RE: Request for further information under section 92(1) of the Resource Management Act 1991 (the Act) – Consent Application Number RM24.184

Attachment 1: OceanaGold (New Zealand) Limited response to Section 92 request in respect of RM24.184

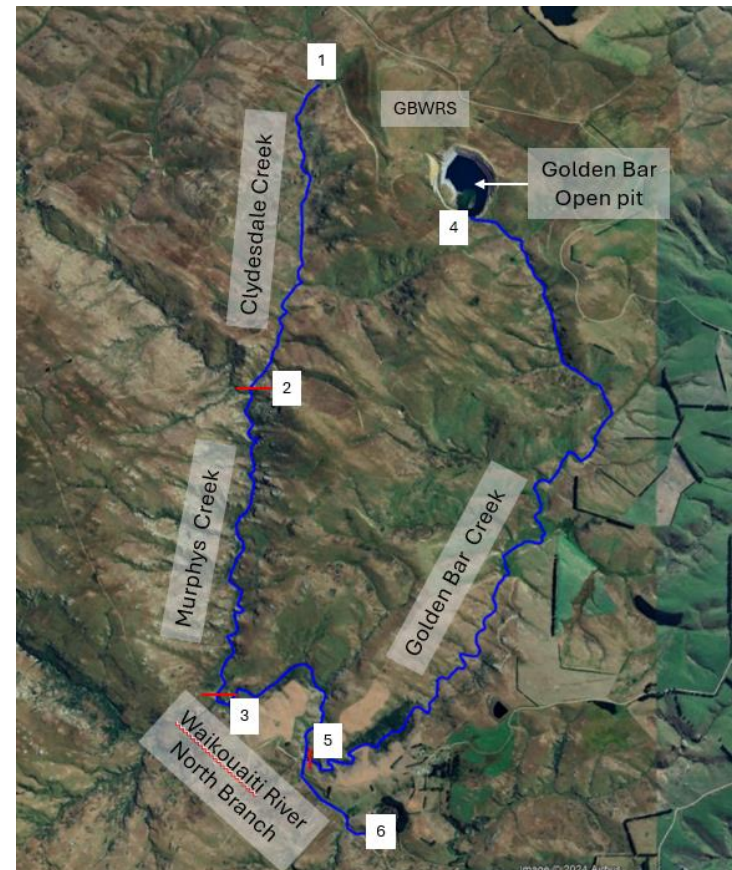
1.31 Please provide coordinates (NZTM2000) for the locations at which the discharge of pit water to the NBWR or Murphys Creek will occur or provide upstream and downstream coordinates between which the discharge will occur.

The image below shows the potential discharge locations as blue lines.

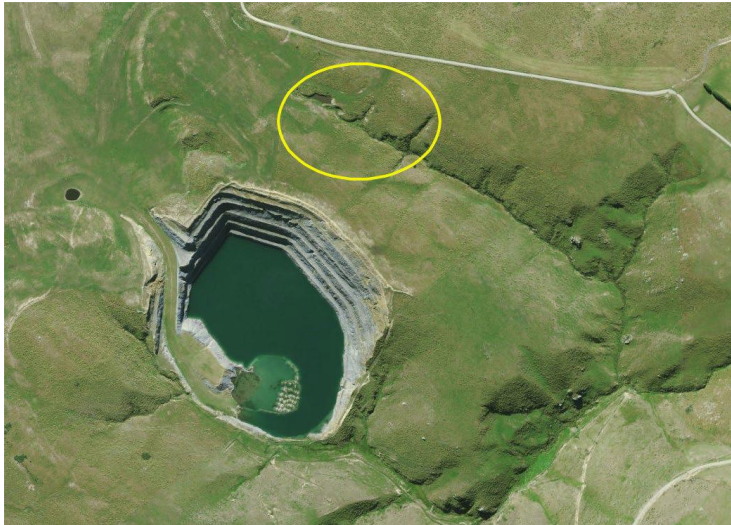
1.34 An application is made to disturb (mine) the bed of a tributary of Golden Bar creek (a length of 130 m including the pond). The relevant rule has been identified as RPW 13.5.3.1. While this is correct, I would also consider that the NES-F regulation 57 (river reclamations) is applicable. I note that AEE s3.6.2 describes this as a reclamation.

- (a) Please confirm that the below image and the yellow ellipse identify the correct tributary and roughly the correct location of the proposed reclamation.
- (b) Please indicate whether OGL agrees to apply under this regulation and please provide an assessment that describes the functional need for the reclamation in this location and applies the effects management hierarchy. If this is already provided as part of the application, please direct me to this assessment.

OceanaGold confirms that the image shown adjacent correctly illustrates the approximate location of the proposed disturbance for which OceanaGold has sought a land use consent. Since the MP4 application was submitted, Whirika (formerly Ahika) has revisited the Golden Bar site and assessed the environments present by applying a river delineation protocol that was agreed with the Otago Regional Council's experts in the context of the BRWRS stream delineation as part of the s92 request in relation to RM22.282. The river delineation protocol is attached as **Annexure 8**. Applying that protocol, Whirika has determined that there is no river within the proposed Golden Bar pit extension. On the basis that this is not 'river', Whirika has further investigated this area to determine whether wetlands are present. That assessment is provided as **Annexure 9** and indicates that by applying a precautionary approach, the area in question is most appropriately classified a mosaic of riparian and wetland vegetation including up to 0.008 ha of natural inland wetland (assuming it contains animals adapted to wet conditions).

OceanaGold therefore requests that its application for a land use consent made under Rule 13.5.3.1 of the RPW be processed as a land use consent under Regulation 45D(2) of the NESF.

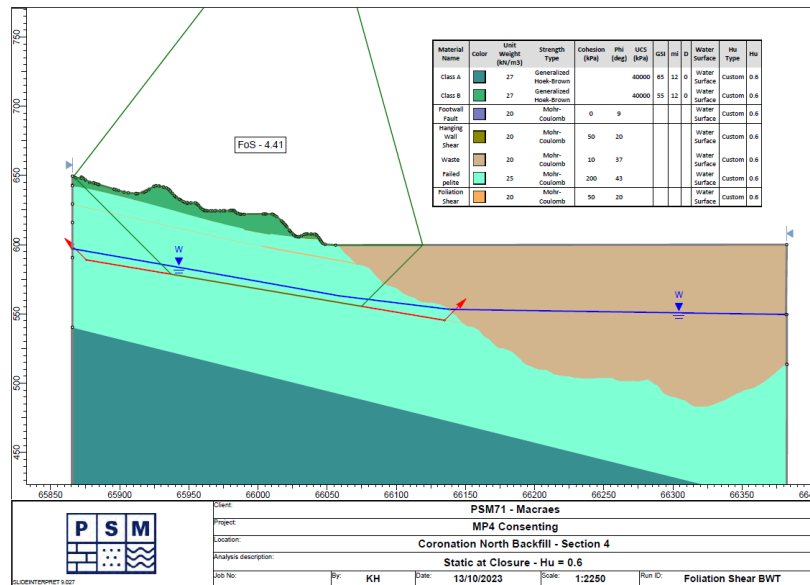
2.7 The EGL (2024b) Trimbells Report adopts a layered model to account for layering that would occur due to the rock placement methodology. Why does the same layering not occur at Golden Bar?

A response to this request is provided by EGL (refer **Annexure 10**).
